BRITISH GLIDING ASSOCIATION

BGA TECHNICAL COMMITTEE

TECHNICAL NEWSHEET TNS 5/6/92

- PART 1 Airworthiness "AGGRO" Please add to the BGA 1992 Red Pages.
- 1.1 Stemme S.10. LBA A/D 92-197 (herewith) requires replacement of the "O" Ring securing the Pitot Probe in the nose.

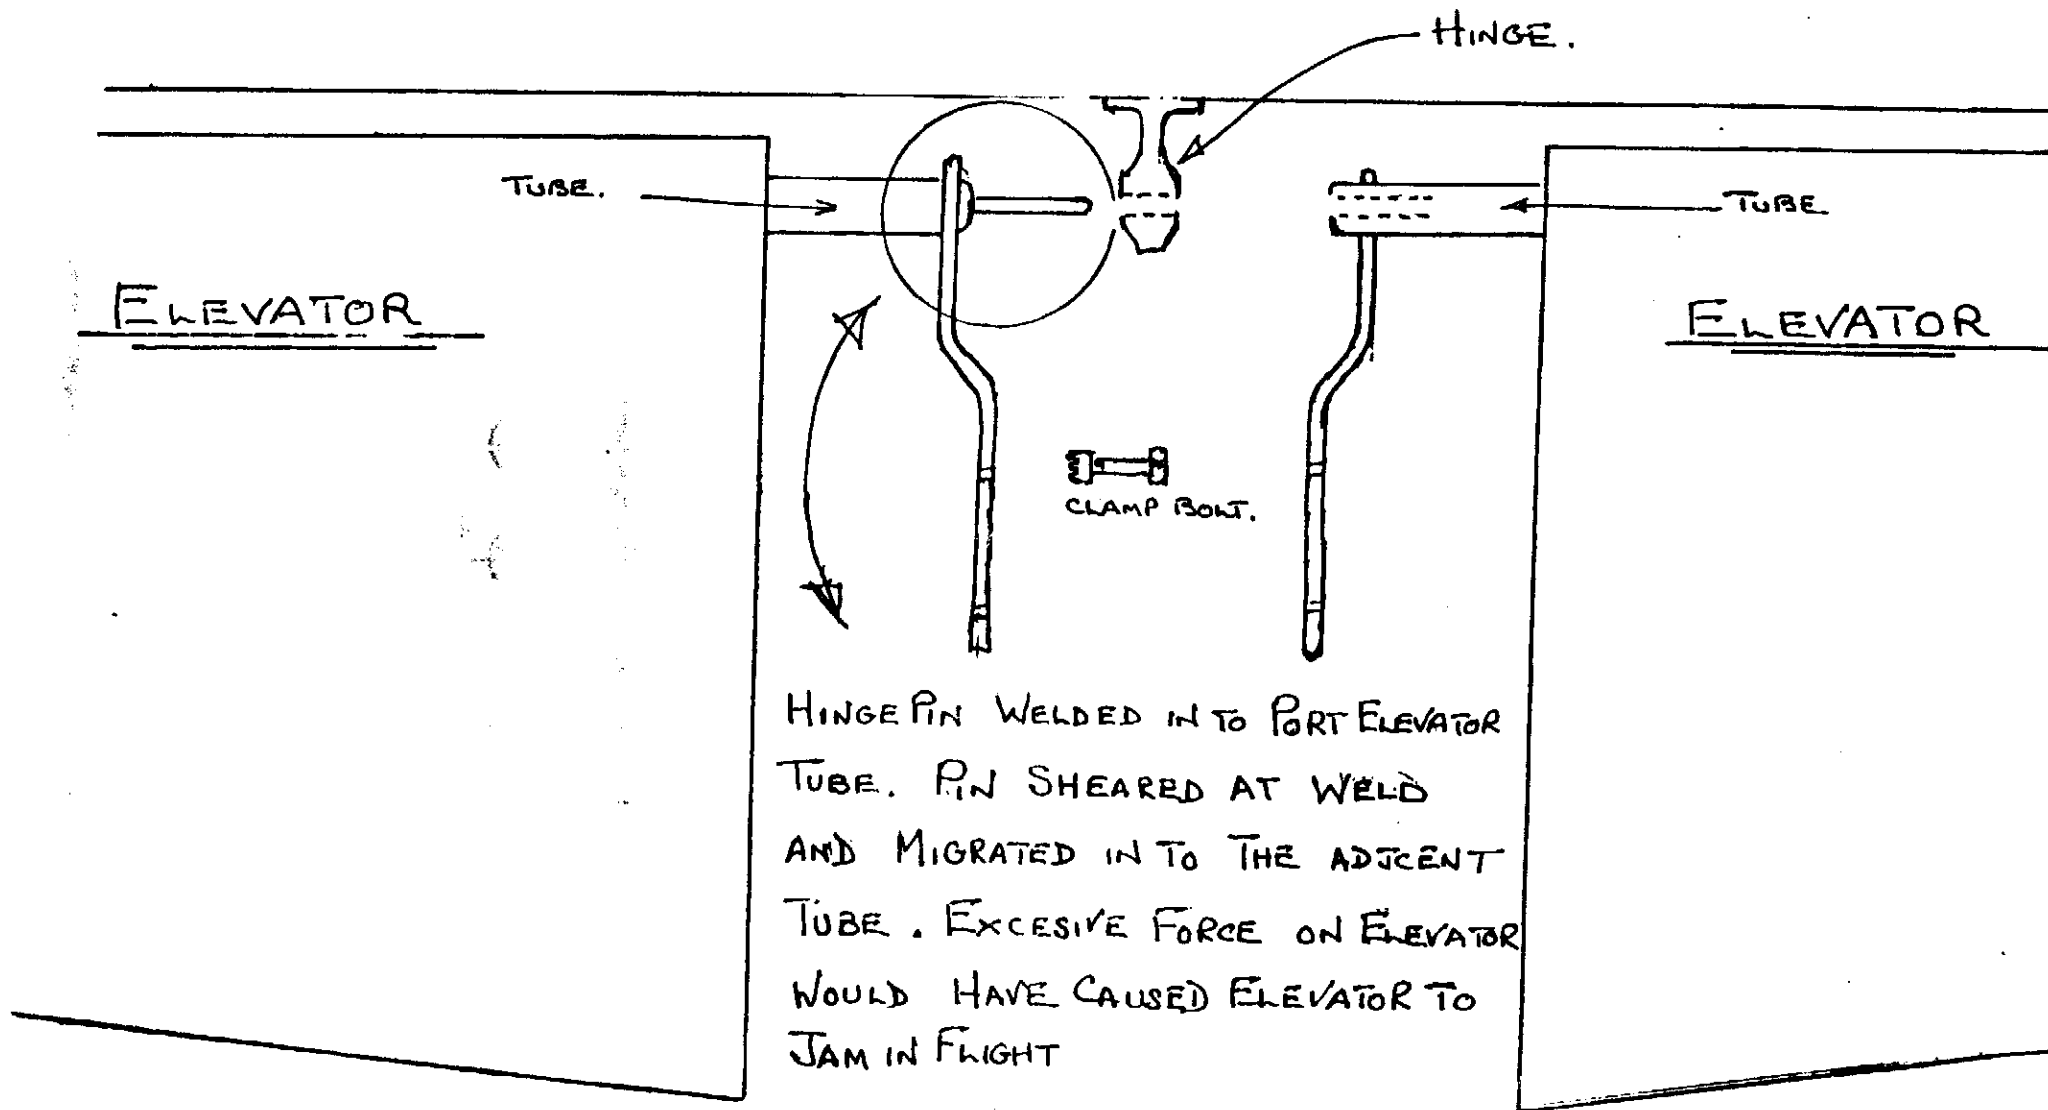
- 1.10 ZUGVOGEL 111B, damage to elevator hinge pin at the weld. Sketch by Colin Sanders herewith, illustrates the problem.
- 1.11 ASTIR STD II. Undercarriage Lever attachment cracked. Sketch herewith from Mr. G.R. Clark - Portsmouth Naval G.C.

HINGE PIN WELDED IN TO PORT ELEVATOR
TUBE. PIN SHEARED AT WELD
AND MIGRATED IN TO THE ADJACENT
TUBE. EXCESSIVE FORCE ON ELEVATOR
WOULD HAVE CAUSED ELEVATOR TO
JAM IN FLIGHT

KAB

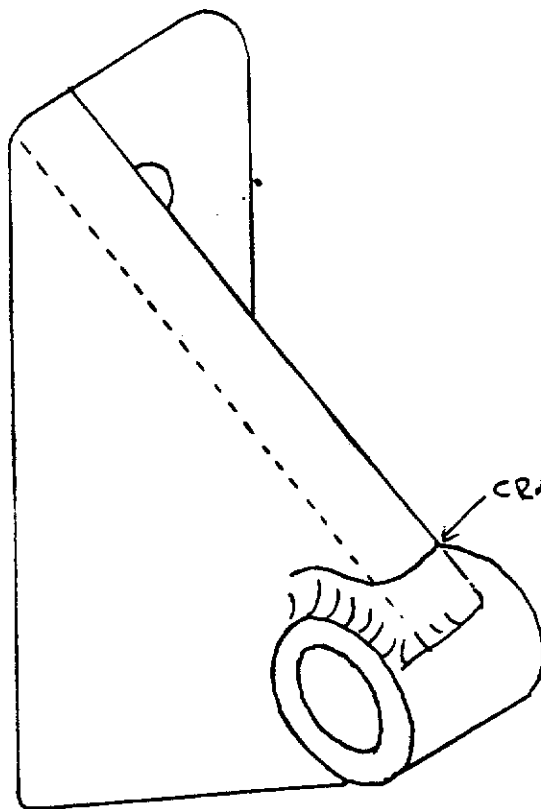
- 1.2 Grob G.109's Airworthiness Directives. Revised list herewith dated April 1992 (Issue 8), must be checked on Scheduled Maintenance.
- 1.3 KA8 Elevator Hinge Cracked. Sketch from Rattlesden G.C. is self explanatory.

PLEASE SEE BELOW A SKETCH OF A KB ELEVATOR HINGE
FOUND CRACKED. ALSO FOUND RECENTLY WAS A KB TOP
RUDDER HINGE, OF THE SAME DESIGN, CRACKED IN A SIMILAR WAY.
THESE RUDDER HINGES ARE ALREADY ^{THE} A SUBJECT OF T.N.S.'S

CRACKED HERE, RUNNING ROUND
THE OUTSIDE OF THE WELD

ASK 13 & ASK 7
 FIN ASSEMBLY
 (WITH LOWER FORMER REMOVED)

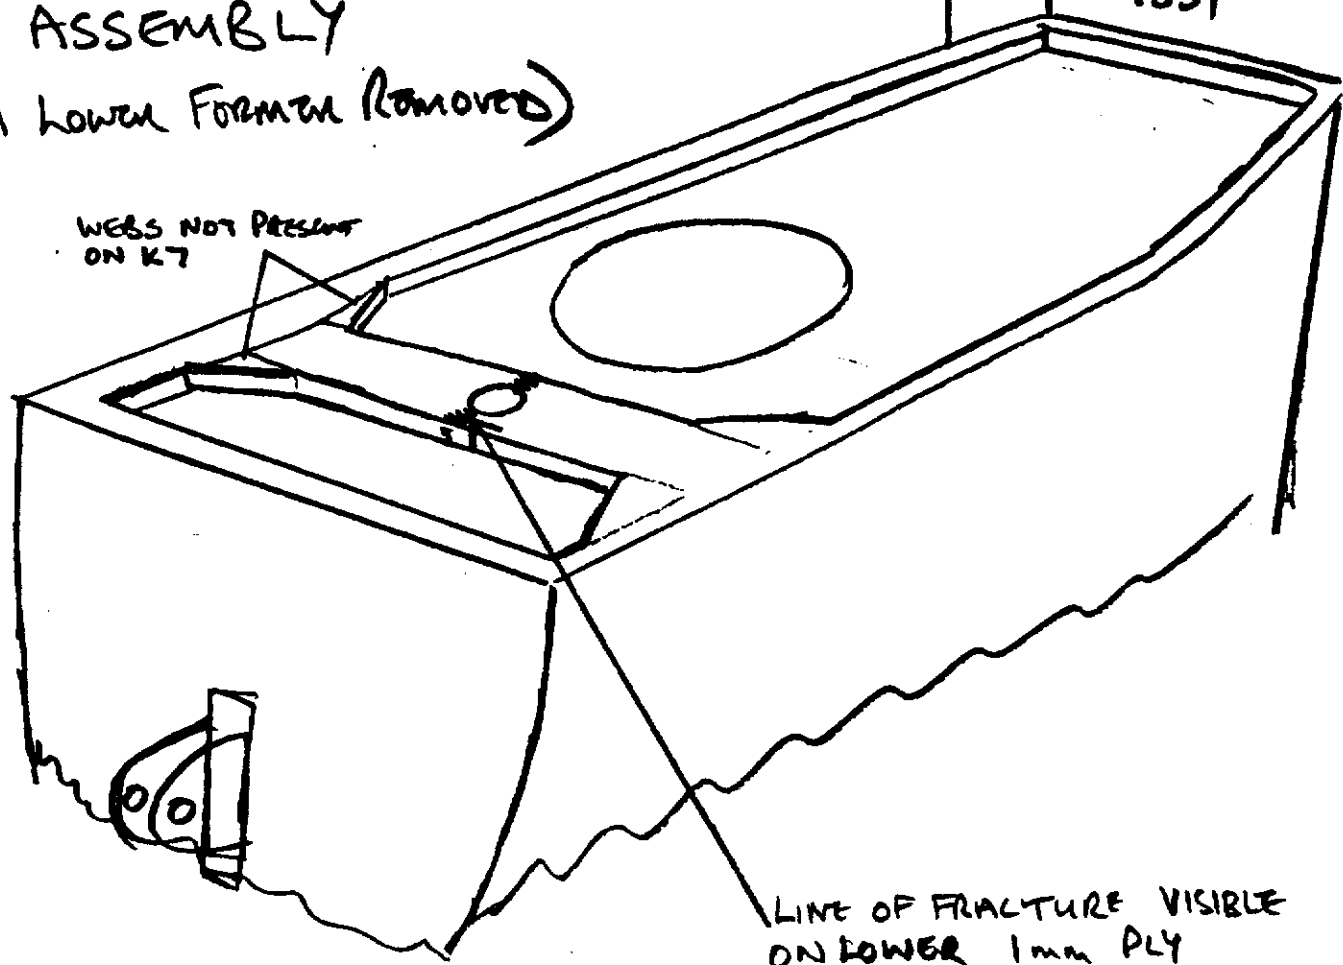
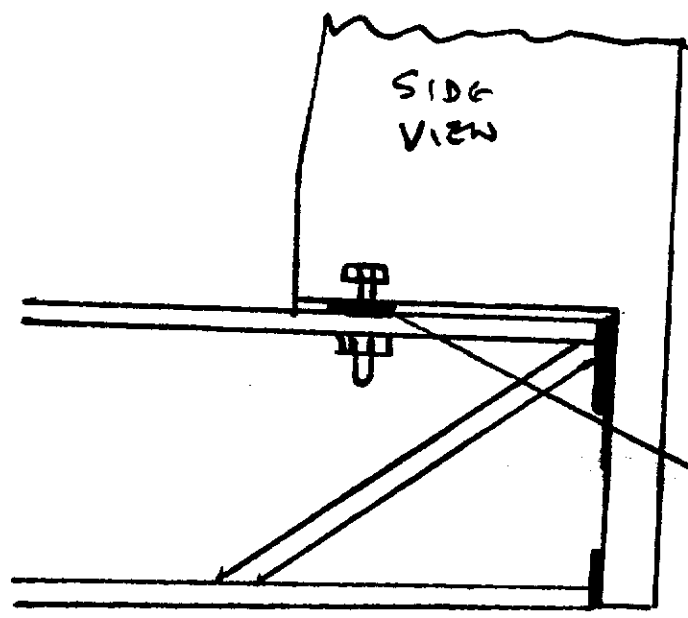
- 1.12 ASK7 & ASK13 Fin Post Damage. Sketch from Steve Wilkinson - Portsmouth Naval G.C. points you towards the problem area.
- 1.13 "Turbo" Engine Vibration Levels can be so high that instruments disintegrate and fill the cockpit with debris! Reported by RAFGSA Cranwell. (Possible advert for Loctite?).
- 1.14 PA18 (Piper Cubs) Failure of the Tailplane Trim Actuator. AAIB Bulletin 4/92 herewith, refers to this recurring problem.
- 1.15 CAA Airworthiness Notice No. 88 herewith requires action to fit LOW BUS BAR WARNING SYSTEMS, on aircraft (including SLMG's), unless the owner/operator applies for a dispensation.
- 1.16 Grob G.109 Aileron / Airbrake Bellcrank - attachment plate and studs found corroded when applying TM 817-29 inspection procedure.

WEBS NOT PRESENT
 ON K7

LINE OF FRACTURE VISIBLE
 ON LOWER 1mm PLY
 FORMER

SUGGESTED PLY
 PACKING TO
 SHIT (GLUED TO LOWER
 FORMER)

ASTIR. II.

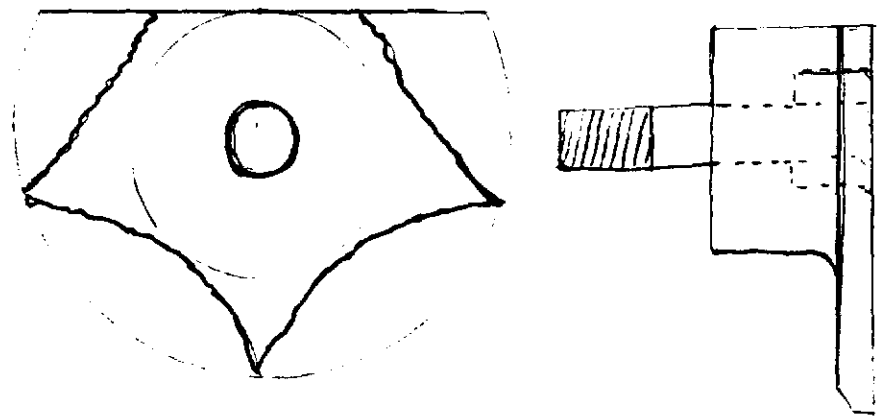
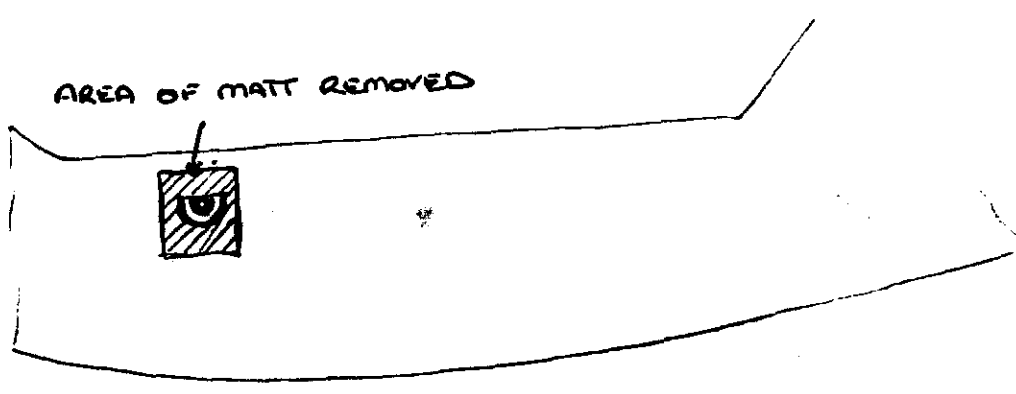
Astir Std II under carriage Lever Retaining Bolt Attachment Plate is cracked in four places.

Whilst carrying out annual C of A the bracket was found to be loose inside the fibre glass sandwich which holds it to the fuselage side wall. Starring of the Gel coat on the outside in line with the leading edge of the bracket was noticed. Further investigation was then carried out.

Four layers of matt were removed which retain the bracket to the fuselage side wall. The bracket was then accessible and found to be cracked in four places.

The bracket seems to be made of a brittle cast alloy.

CRACKED IN FOUR PLACES AS INDICATED

Tailplane Trim Mechanism Installation - Schematic

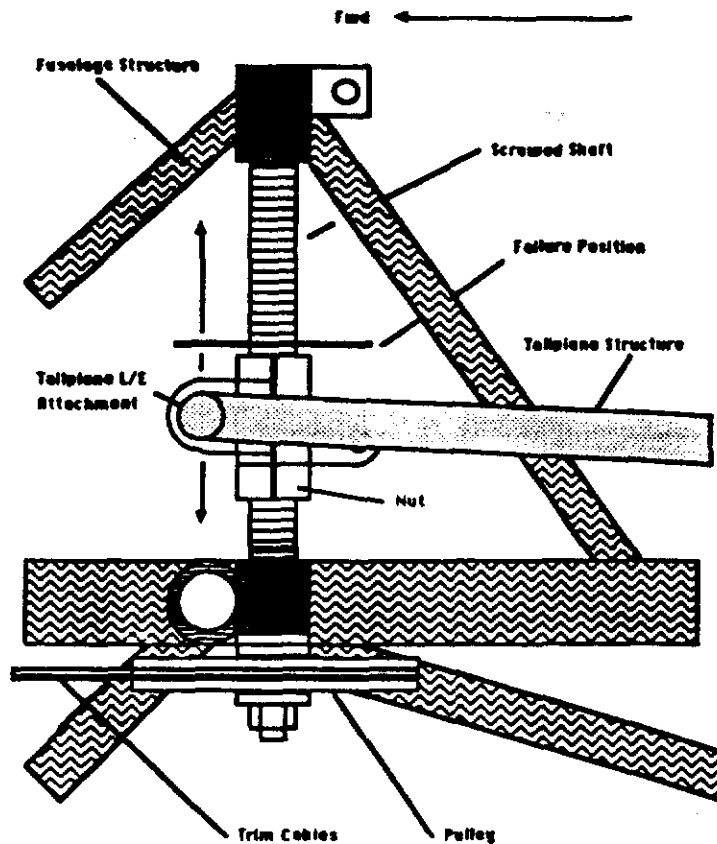
As the aircraft accelerated in a descent from 2000 feet on the second aerotow of the day, the pilot operated the pitch trim handle to trim nose-down, only to find that he could not 'trim out' the stick forces. The remainder of the flight was conducted with a large measure of nose-up trim which resulted in a difficult, but uneventful, landing. Subsequent examination of the aircraft revealed that the pitch trim screwjack had broken into two sections but had been retained, as the screw is effectively held captive between its upper and lower bushes.

Pitch trim on this aircraft is effected by altering the incidence of the tailplane. This is accomplished by the tailplane pivoting about its trailing edge, with the leading edge attached at its centre to a nut which runs on a screw-shaft mounted vertically in the airframe. The shaft is rotated by cables from a handle in the cockpit, there being approximately 25 turns of the handle required for full travel. During aerotow operations this trim system is in almost constant use, compensating for large variations in pitching moments due to flap, power and speed changes. The aircraft is also subject to considerable vibration, particularly during the low speed, full power, climb segment of each flight.

The shaft had failed at its mid-point within a region which exhibited excessive wear on the screw thread. Evidence of fatigue cracking was present on the fracture surfaces, originating from the entire circumference of the thread root. Metallurgical examination of the screw material showed it to conform to the manufacturer's specification.

The shaft was fitted to the aircraft in March 1984 and had accumulated a total time of 2,448 hours. Data extracted from the records showed that, on average over the life of the screw, the aircraft had achieved 6.89 aerotows per hour, with a total number of flights of 16,866. The last recorded maintenance on the screw was in August 1991, 102 hours before the failure, when it was found to be 'loose'. It was re-shimmed, tested and found to be satisfactory. Comments were made by an experienced engineer on type to the effect that any excessive shimming used to eliminate side play on the tailplane front or rear attachments can result in high friction in the system and introduce side loads on the screw. He also stated that a check for increased friction should be accomplished after such shimming. There is no related guidance given in the Maintenance Manual on this subject.
